ACCESSION NBR: 8405030127 DOC. DATE: 84/04/25 NOTARIZED: NO DOCKET #
 FACIL: 50-261 H. B. Robinson Plant, Unit 2, Carolina Power and Light 05000261
 AUTH. NAME AUTHOR AFFILIATION.
 CUTTER, A. B. Carolina Power & Light Co.
 RECIP. NAME RECIPIENT AFFILIATION
 VARGA, S. A. Operating Reactors Branch 1

SUBJECT: Forwards Attachment 1 Rev 1 to pending exemption request from App R, Section III.G.2 re proposed mods to component cooling water pump room. Changes involve addition of partial area suppression.

H. B. ROBINSON STEAM ELECTRIC PLANT, UNIT NO. 2
DOCKET NO. 50-261/LICENSE NO. DPR-23
FIRE PROTECTION
CCW PUMP ROOM EXEMPTION REQUEST

H. B. Robinson Unit No. 2
Additional Information On Pending Exemption Request

Figure 1 ELEVATION OF COMPONENT COOLING WATER AREA

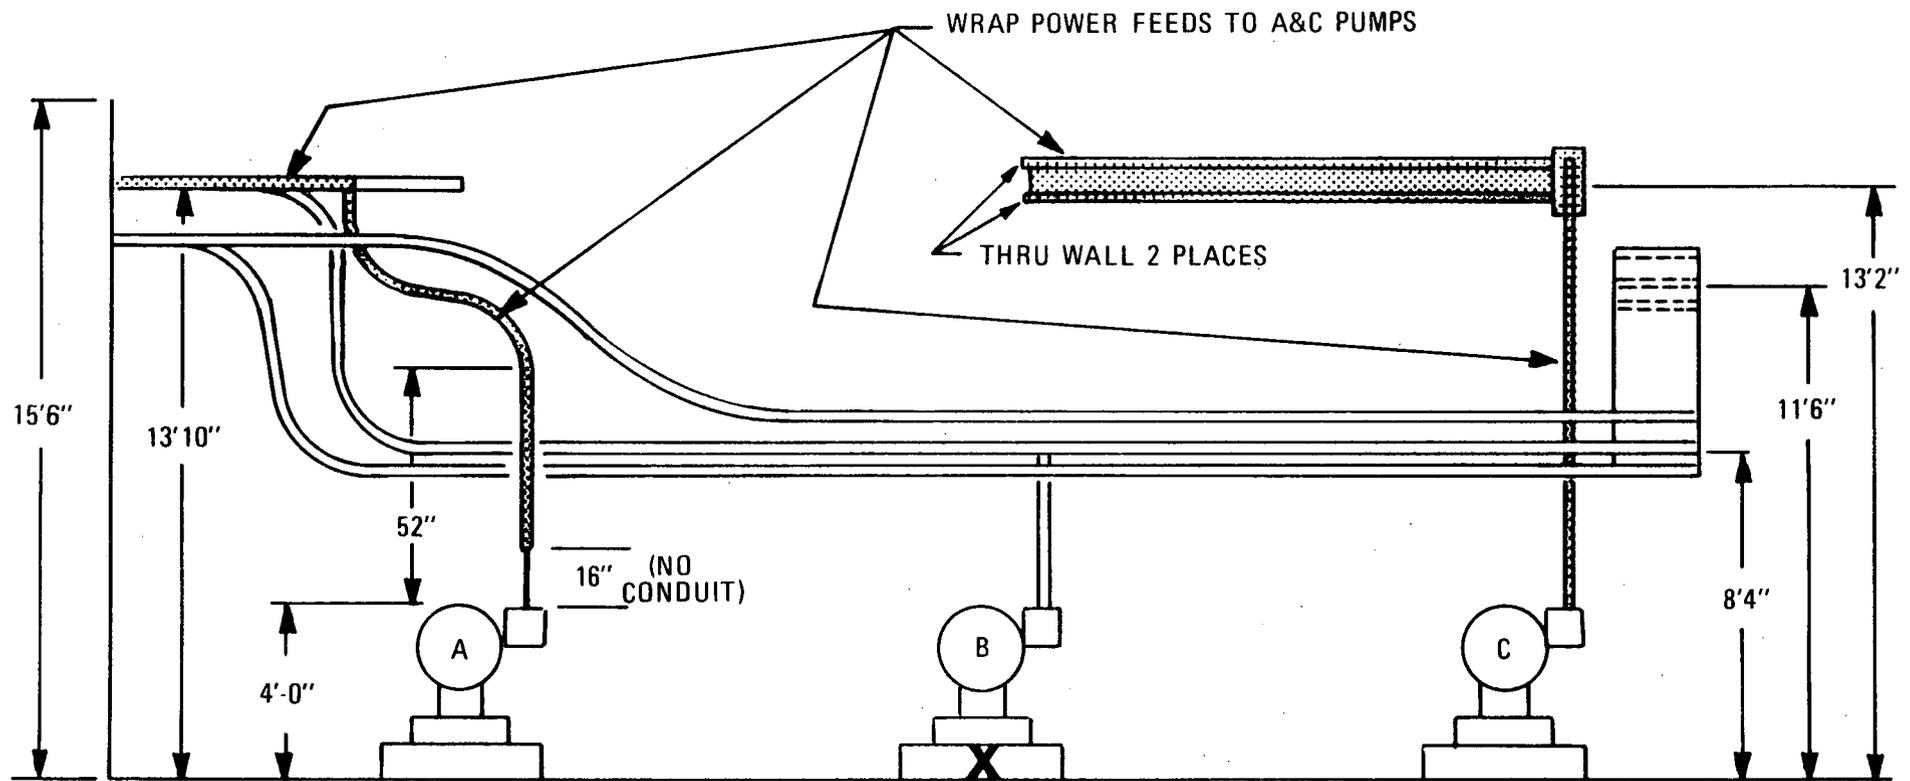
The component cooling water pumps are located on a north-south orientation, with pump A redundant to pump C (Figure 2). Pumps A and C are 24 ft from centerline to centerline with approximately 20 ft (19' 11") between the closest points of each pump (See Figure 1). Only one of three (3) pumps and one (1) component cooling heat exchanger are required for safe shutdown.

The pump power supply cables for component cooling water pumps A and C are installed in conduit (Photographs 1, 2, 4-7). The pump A power cable currently is routed through conduit which empties into a tray. Power cables for both pumps are horizontally separated by 12 ft with the highest tray located 13 ft 10 in off the floor (Figure 1).

NOTE: POWER FEEDS TO PUMP "A" CURRENTLY IN TRAY
TO BE REROUTED IN CONDUIT AND WRAPPED.

NOTE: POWER FEEDS TO PUMP "A" CURRENTLY IN TRAY TO BE REROUTED IN CONDUIT AND WRAPPED.

Figure 2 PLAN OF COMPONENT COOLING WATER AREA

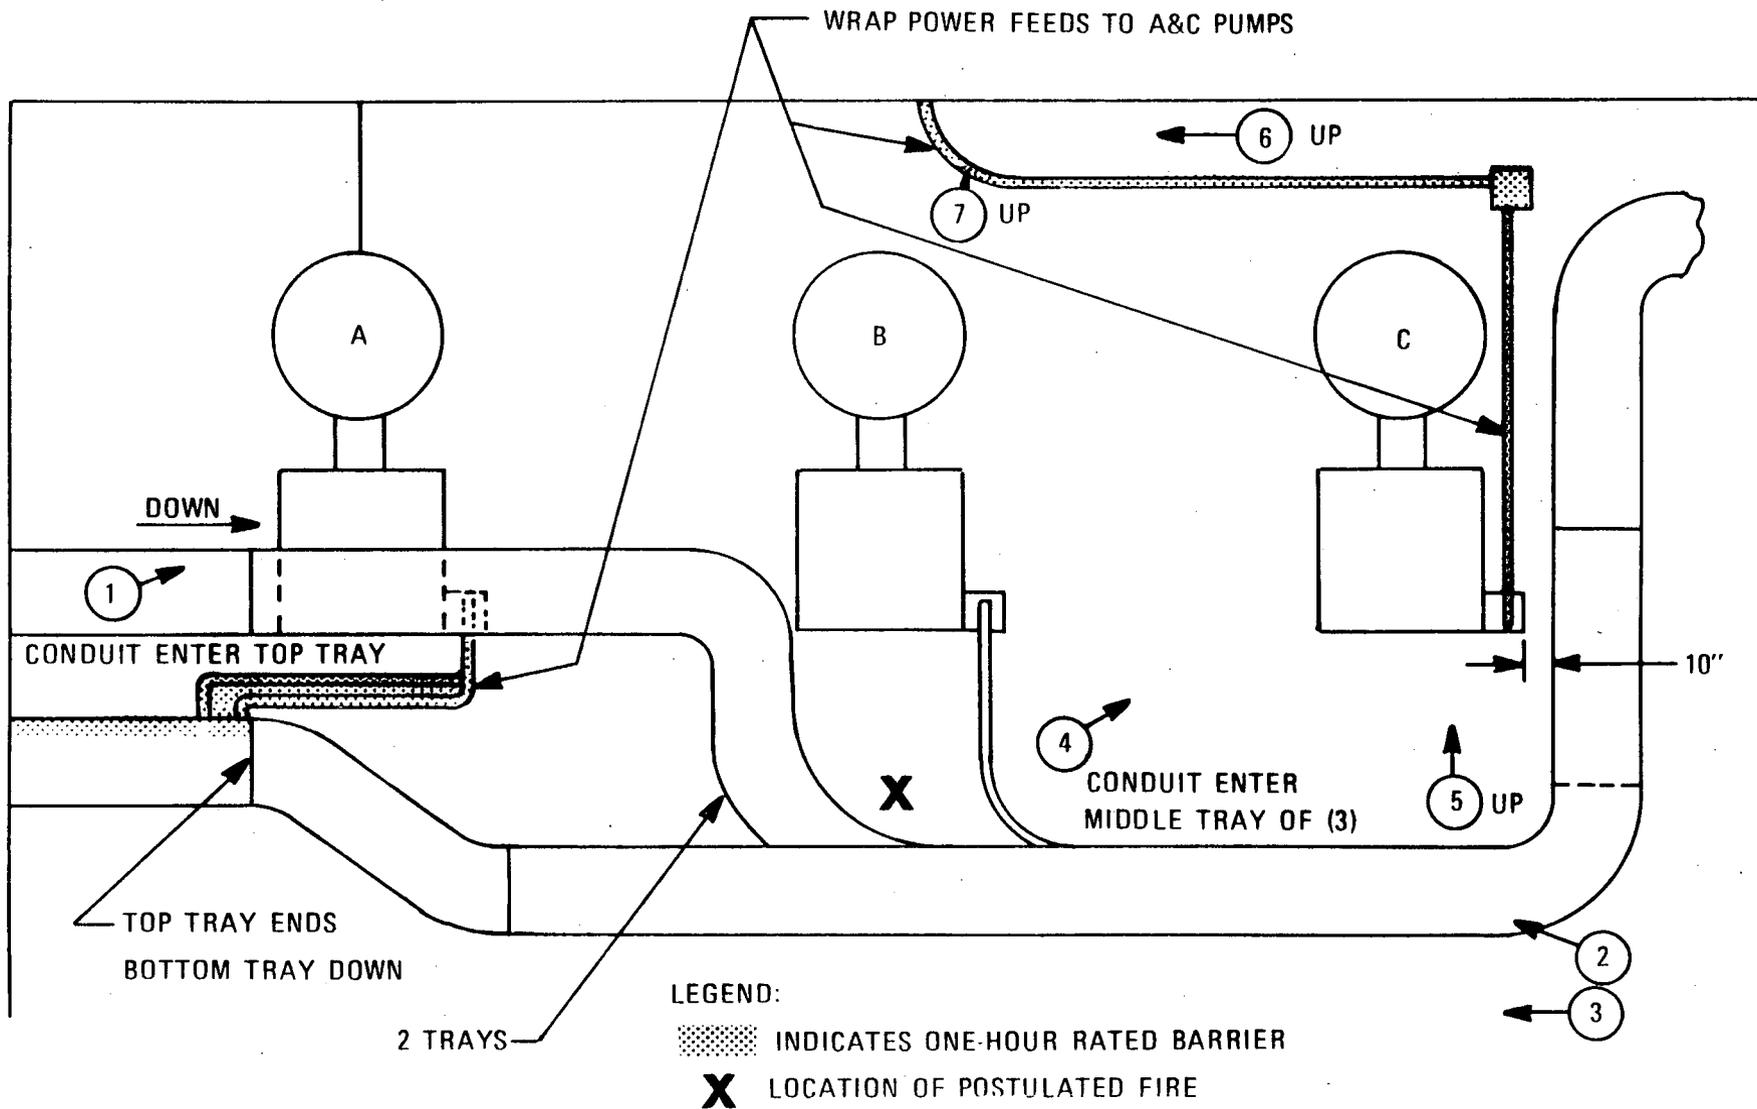
In order to maximize the impact of a postulated exposure fire on the redundant pumps A and C, the transient combustible materials are assumed to be located directly in front of pump B, equidistant between the pumps (Figure 2). This location allows for radiation from the flames to directly impact both pumps simultaneously. An analysis of the effects of a fire is performed (Appendix A) which assumes that all radiant energy from the exposure fire will be viewed by the pump motor casings with no re-radiation to other energy-absorbing materials in the area and no natural convection to remove energy from the pump casings. The fire brigade would respond immediately for a fire in this area, nevertheless, the proposed suppression system would automatically actuate and suppress the fire.

Figure 3 COMBUSTIBLE LOADING CONFIGURATION IN COMPONENT COOLING WATER AREA

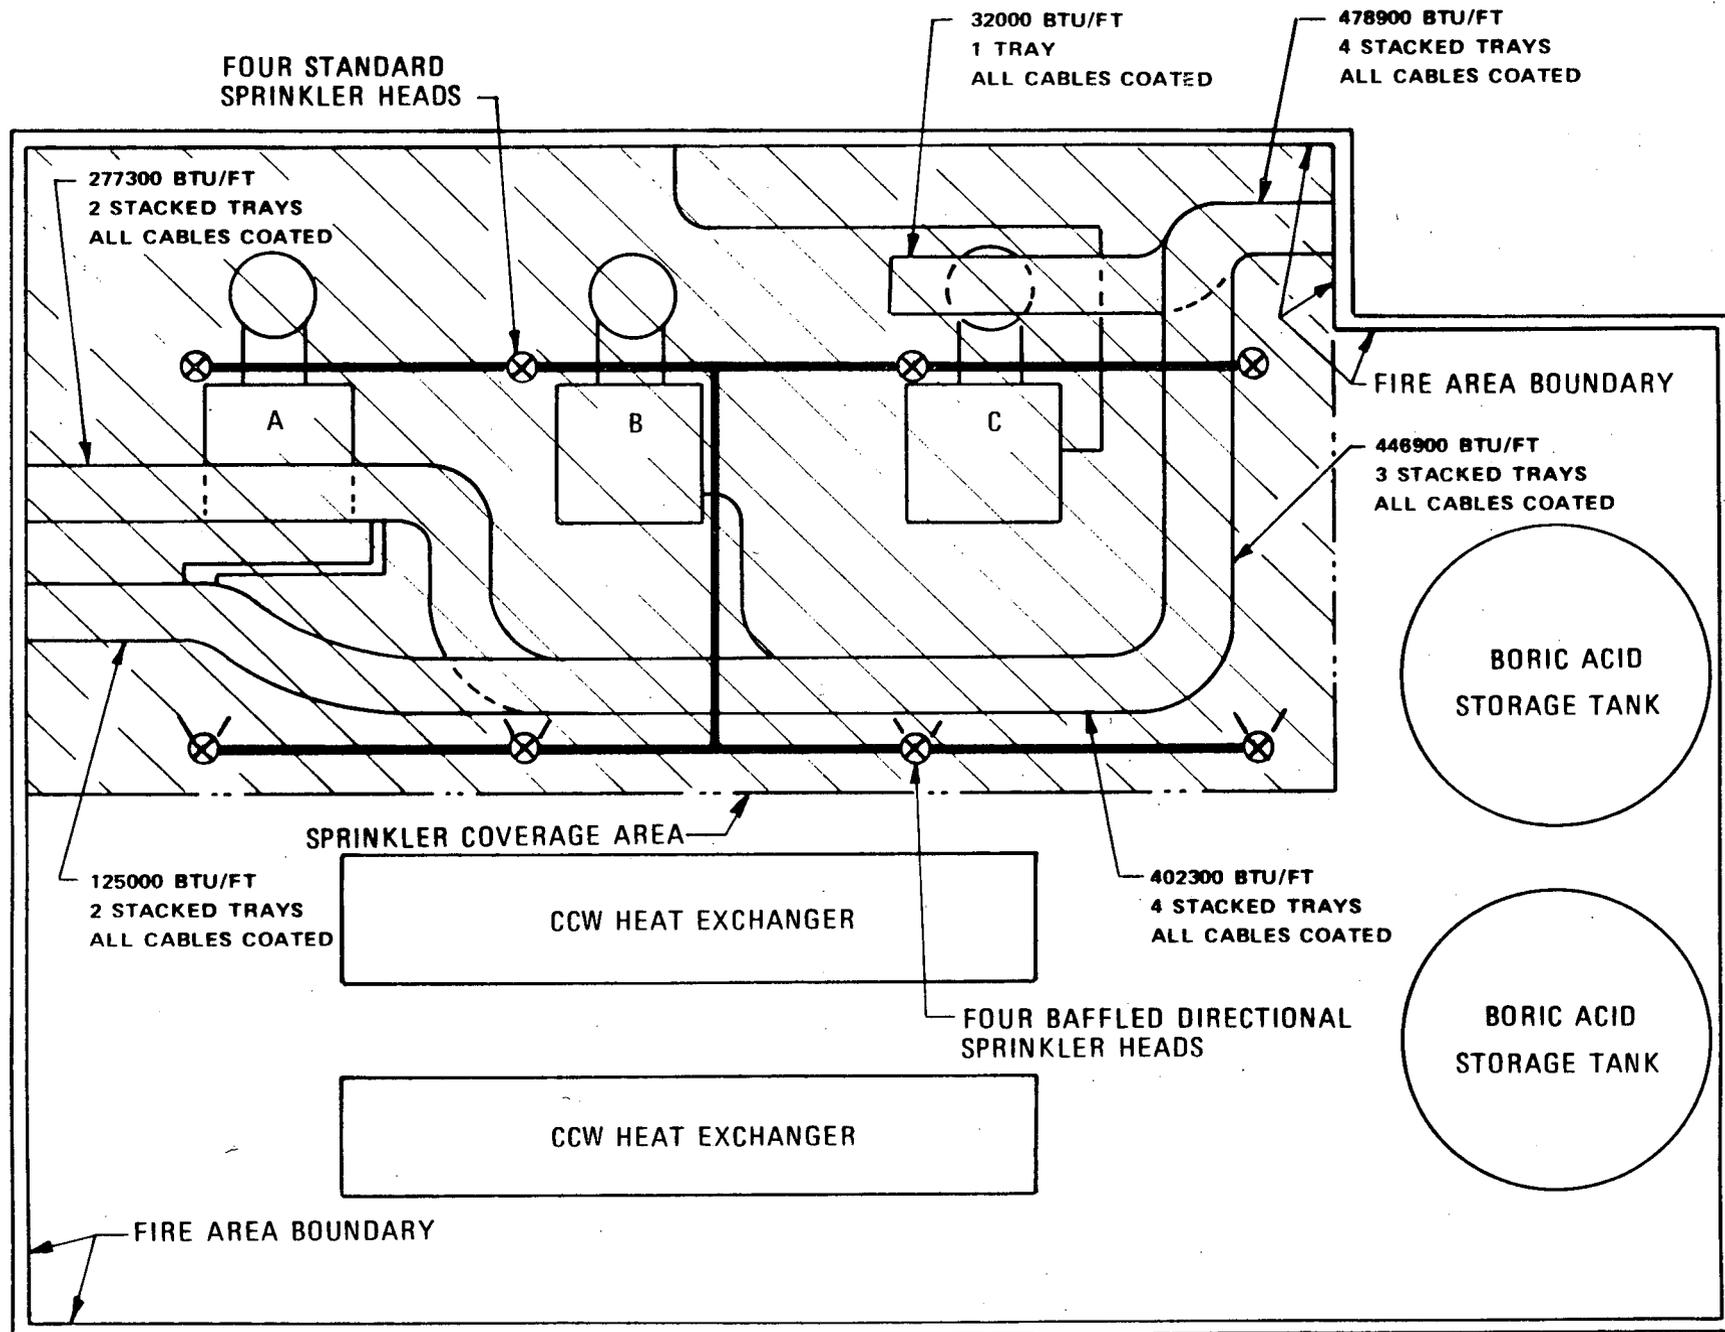
Changes to the attachment are indicated by vertical bars in the right-hand margins. Briefly, the changes involve the addition of the partial area suppression (refer to Figure 3) along with our proposal to delete the previously-proposed plume-impingement barrier beneath Balance of Plant cable trays in the area and our intention to remove the existing radiant heat shield wall adjacent to CCW Pump A.

To enhance the protection of the component cooling water pump room and preclude ignition of the power cables to both pumps A and C, CP&L proposes to provide a one (1) hour barrier around the power supply cables for pumps A and C. In addition, a partial fire suppression system will be installed in the area of the component cooling water pumps and the aisle in front of the pumps. (See Figure 3.)^{1/}

NOTE: SPRINKLER SYSTEM TO BE INSTALLED AT CEILING HEIGHT

from the present conduit-tray routing to a conduit. In addition, a partial fire suppression system will be added above the cable trays and pumps to prevent the migration of fire between the redundant pumps A and C. The proposed fire protection system will be a preaction sprinkler system and integrated with the existing detection system described above.

1. Reroute pump A power cable to conduit and provide one (1) hour rated barriers around the power cables for pumps A and C
2. Partial fire suppression system as defined below:

A preaction sprinkler system will be hydraulically designed to meet the requirements of NFPA 13-1983 with respect to density and area of coverage. The occupancy is considered to be "Ordinary Hazard, Group 1."
